**STAFF REPORT: REGULAR CALENDAR**

APPLICATION NO.: 4-00-128

PROJECT LOCATION: 25700 Mulholland Highway, Calabasas, Los Angeles County

PROJECT DESCRIPTION: Construction of an 834 sq. ft. horse barn with approximately 48 cu. yds. of grading (cut and fill) and after-the-fact approval for an 11,000 sq. ft. sand horse arena with approximately 50 cu. yds. of grading (cut and fill).

Exhibit 5
4-00-128
Fuel Modification Exhibit

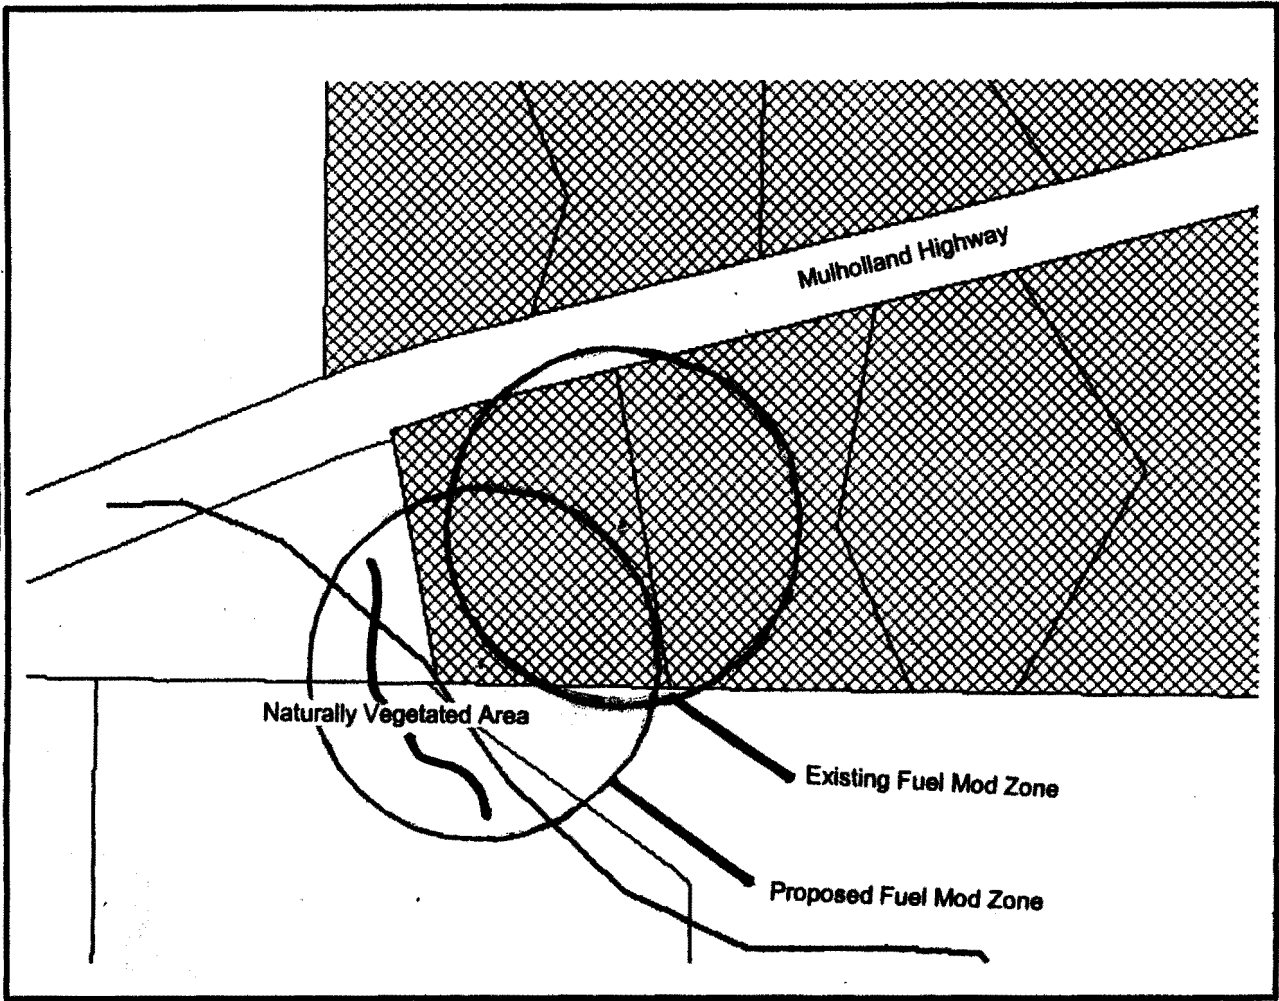
The applicants have submitted a Fuel Modification Plan for the proposed development. The Commission notes that no fuel modification will occur within environmentally sensitive habitat areas of the Cold Creek Resource Management Area located south of the project site. However, the Fuel Modification Plan indicates that fuel modification requirements for the horse barn in its proposed location will result in disturbance of native vegetation on adjacent properties, beyond that which is required to protect the existing residence.

The Commission notes that a majority of project site is subject to fuel modification requirements imposed for fire hazard protection of the existing residence. Developed parcels to the north and east of the subject site are also subject to fuel modification requirements imposed for adjacent development on those parcels (Exhibit 5). However, significant natural vegetation remains on adjacent parcels to the west and south of the site, which are currently only subject to a ten ft. wide brush clearance zone along a private access road. The applicants are proposing to construct a new 834 sq. ft. horse barn at the south-west corner of the subject site. A Fuel Modification Plan with Preliminary Approval of the County of Los Angeles Fire Department Forestry Division indicates that regular fuel modification requirements will be imposed for the proposed barn. The Fuel Modification Plan indicates that, due to the location of the proposed barn at the south-west property boundary, vegetation clearance/thinning requirements will exceed the fuel modification requirements presently imposed for the existing residence by approximately 160 ft. at the south-west portion of the property. The extended fuel modification zone required for the proposed barn would result, on average, in approximately 100 ft. of brush clearance on three adjacent parcels to the west and south of the subject site, parcels that are presently not affected by vegetation clearance requirements for the existing development, which retain significant natural vegetation (Exhibit 5). Currently, the brush clearance zone for the existing residence overlaps with other fuel modification requirements imposed on adjacent development to the north and east of the site, but extends approximately 27 ft. on one adjacent parcel directly south of the site's south-east property boundary. As such, project plans

submitted for the proposed barn indicate that vegetation clearance/thinning requirements for fire protection of the proposed structure will result in new adverse impacts on natural vegetation existing to the west and south of the site. To ensure that the proposed project does not result in adverse impacts to significant natural vegetation surrounding the site, the Commission finds that revised plans shall be required, as stated in **Special Condition 3**, which show that the horse barn is deleted from the plans, is modified with respect to building materials, or is relocated to the area of the approved horse arena, such that fuel modification requirements for the barn do not exceed that which is currently required for the residence. Additionally, the Commission requires the applicants to submit Final Fuel Modification Plans approved by the County of Los Angeles Fire Department Forestry Division, as described in **Special Condition 4**, to ensure that fuel modification requirements for the proposed horse barn, as revised to be consistent with **Special Condition 3**, do not exceed that necessary to protect the single family residence.

Prior to issuance of Coastal Development Permit 4-00-128, the applicants shall submit, for the review and approval of the Executive Director, revised project plans which show that the proposed 834 sq. ft. horse barn is deleted from the plans, is modified with respect to building material, or is relocated on the subject site to the area of the horse arena approved pursuant to this coastal permit, such that the structure does not require fuel modification which exceeds that currently necessary to protect the existing single family residence.

Prior to issuance of Coastal Development Permit 4-00-128, the applicants shall submit Final Approved Fuel Modification Plans approved by the County of Los Angeles Fire Department Forestry Division, for the review and approval of the Executive Director, which indicate that fuel modification requirements for the proposed horse barn shall not exceed beyond that necessary to protect the single family residence.
